**SUBDIVISION, PLANNED UNIT DEVELOPMENT  
& SIDEWALK WAIVER STAFF REPORT****Date: April 3, 2008**

**APPLICANT NAME** Austal USA, LLC (Dees Engineering Services, Inc., Agent)

**SUBDIVISION NAME** Austal USA Modular Manufacturing Facility (MMF) Subdivision

**CONTEMPLATED USE** Subdivision approval to create 1 lot, Planned Unit Development approval to allow multiple buildings on a single building site and sidewalk waiver to waive the construction of sidewalks along Dunlap Drive and Addsko Road.

# SITE PLAN

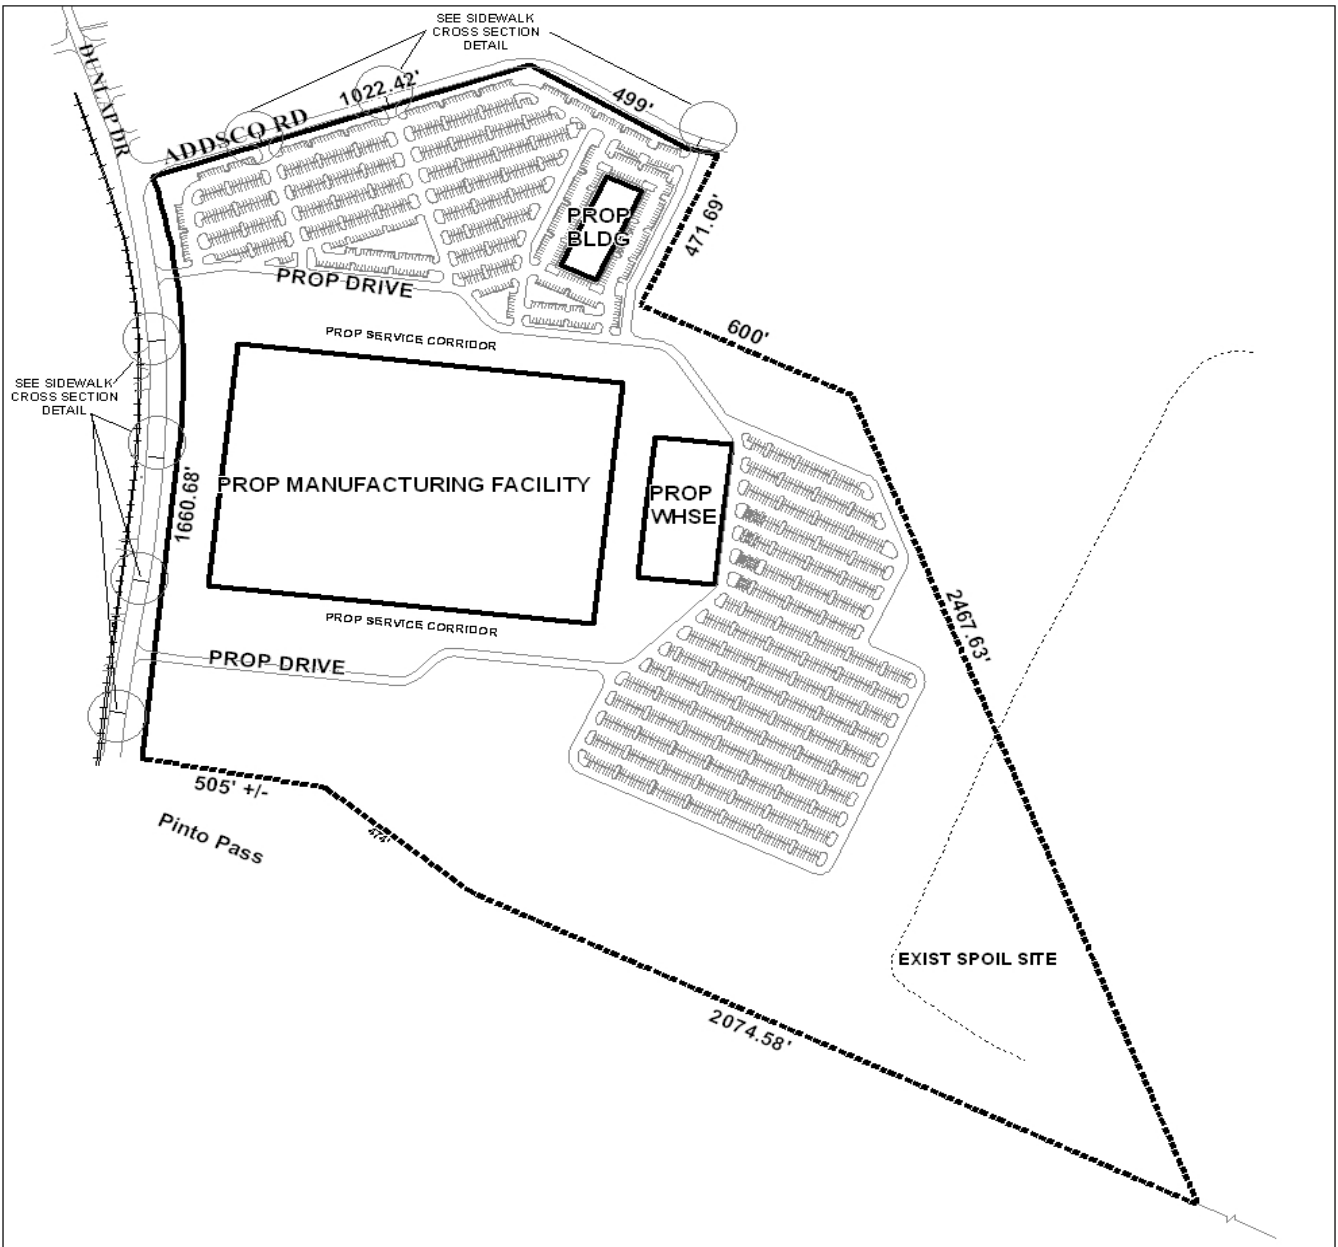
The site plan illustrates a 700' x 1,000' (700,000 square feet) modular manufacturing facility (MMF), a 200' x 400' (80,000 square feet) warehouse, and a 100' x 280', two-story (28,000 square feet) administrative building. The proposed site illustrates 3,057 parking spaces to accommodate employees at the existing building and the proposed construction. The applicant list the existing number of employees (1,800) and the proposed number of employees of the MMF (1,038), warehouse (12) and the administrative building.

The Zoning Ordinance requires one parking space per three manufacturing/warehouse personnel and one space per 300 square feet of office/retail space. Therefore, the required parking spaces for the completed project would be 1,137 spaces. The site would provide for three times the required parking spaces for this use; however, the Ordinance does not have a maximum number of parking spaces for a site.

Access management is a concern due to the site fronting on two streets; therefore, the development should be limited to three curb cuts to Addesco Road, and to five curb-cuts, to Dunlap Drive, with the size, design and location of all curb-cuts to be approved by Traffic Engineering and conform to AASHTO standards.

**Planned Unit Development:** Based upon the preceding, the PUD request is recommended for Approval, subject to the following conditions:

- 1) completion of the Subdivision process;
- 2) the submission of a revised PUD site plan reflecting compliance with the landscaping and tree requirements of the Zoning Ordinance;
- 3) full compliance with all other municipal codes and ordinances.

# SIDEWALK CROSS SECTION DETAIL

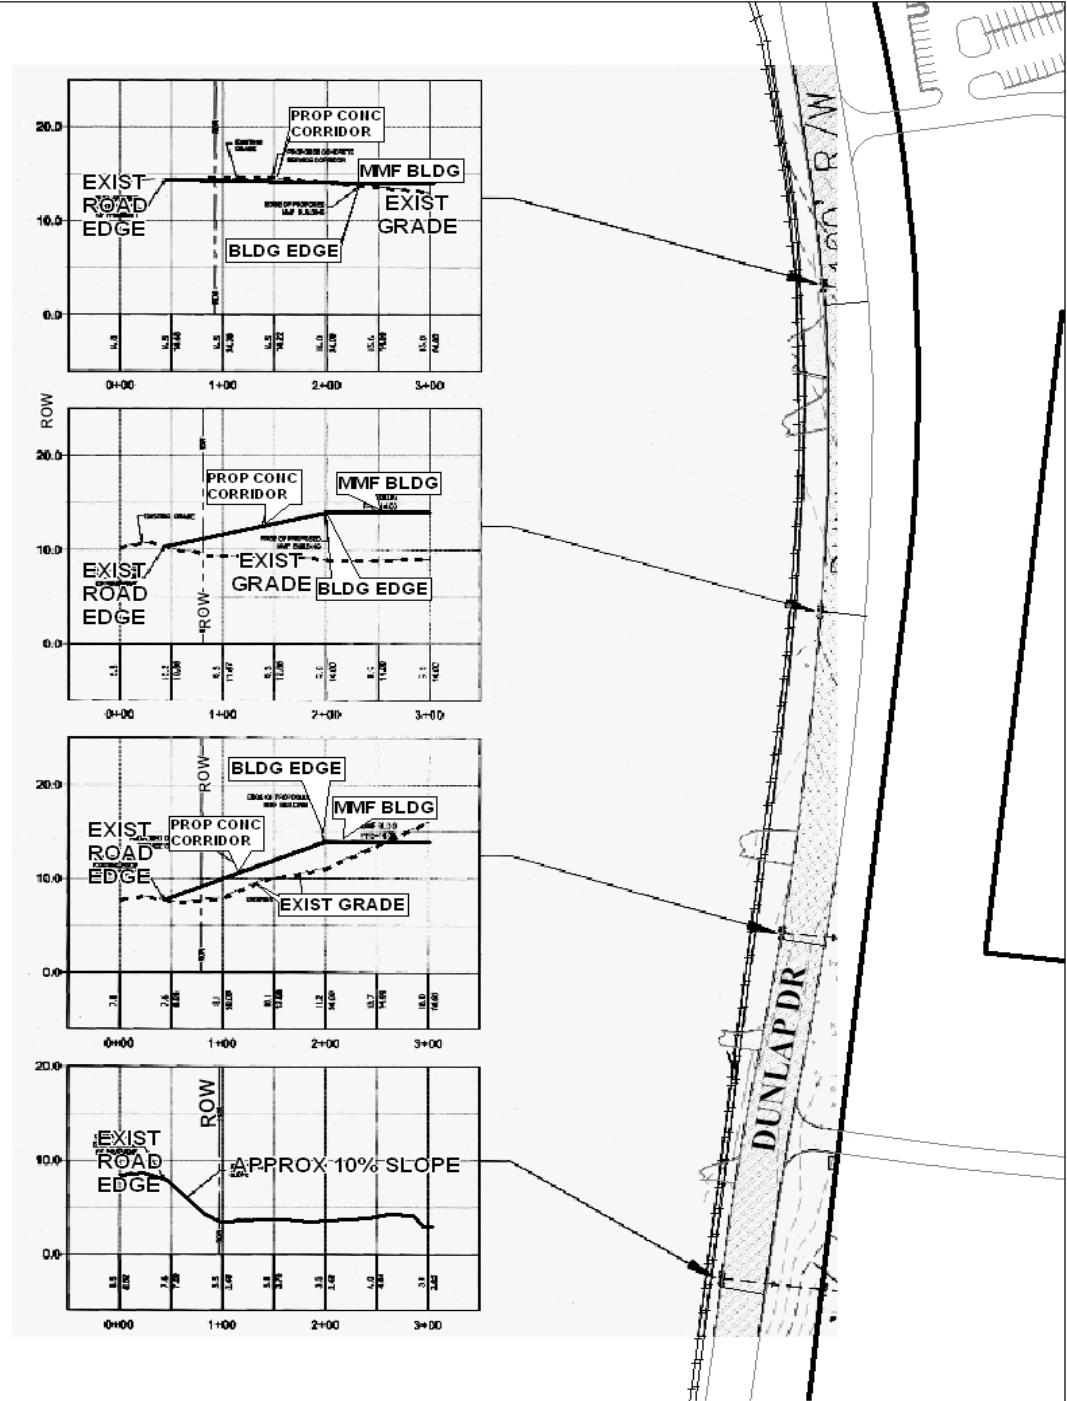
The applicant is also requesting the waiver of the construction of sidewalks along Dunlap Drive and Addesco Road.

The applicant states that this area is an industrial zone; therefore, not conducive to construct sidewalks within this area.

It should be noted that there have been sidewalk waivers approved located within the immediate area; however, these waivers did not propose workers travel along rights-of-way to and from their parking areas to work.

As Engineering Department states the applicant did not provide any information that a City standard sidewalk could not be constructed.

**Sidewalk Waiver:** Based upon the preceding, this application for waiver of the sidewalk along Addsko Road and Dunlap Drive should be denied u, for the following reasons:

- 1) the applicant did not provide any information that a City standard sidewalk could not be constructed.
